INSTRUCTIONS FOR REPLACING THE 153560
SHAFT WITH BUSHINGS ON A MODEL 28 TYPING
UNIT (LP6 AND UP) AND A MODEL 28 SEQUENTIAL
SELECTOR USING THE 154789 MODIFICATION KIT

FIGURE 1

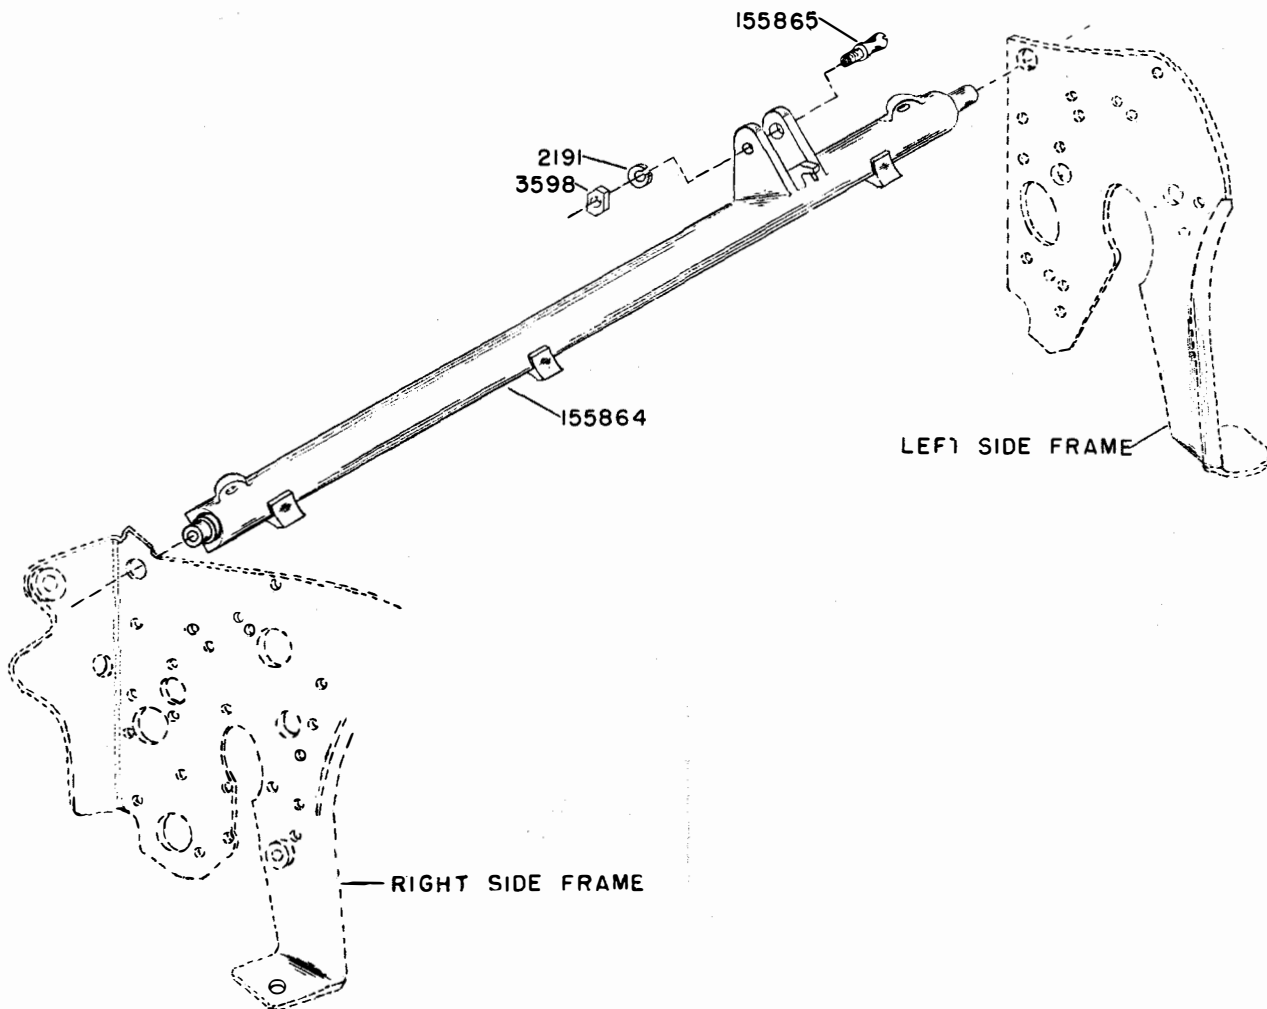
a. The 154789 Modification Kit provides a field replacement for the 153560 Shaft on a Model 28 Typing Unit (LP6 and up) serial numbers below 66087, and a Model 28 Sequential Selector, serial numbers below 1150, with one of improved design. General replacement of old style designed shaft is not recommended.

e. Loosen the two 2539 Nuts at the ends of the 153560 Shaft with bushings so that they are free from the 150414 Bushings. Position the 150414 Bushings sufficiently to the side and remove and discard the 153560 Shaft with bushings. Retain the 2539 Nuts, 90819 Felt Washers, and 73175 Lock Washers. Discard the following parts mounted on the 153560 Shaft with bushings: Three 153580 Cams, one 153554 Bracket with pin, two 153579 Spring Arms, ten 151657 Screws, and nine 2191 Lock Washers.

f. Install the 155864 Cam Shaft with end having the ears which fasten to the 153558 Link in the right side frame, when viewing the typing unit from the front, using the 90819 Felt Washers, 2539 Nuts, and 73175 Lock Washers previously removed.

i. Install the free end of the 153558 Link between the two ears on the 155864 Cam Shaft using the 2191 Lock Washer, 3598 Nut, and the 155865 Stud.

The threaded end of the stud should be pointed toward the long end of the shaft. The notch-end of the link should be toward the shaft and the large flat part of its bushing should be toward the short end of the shaft.
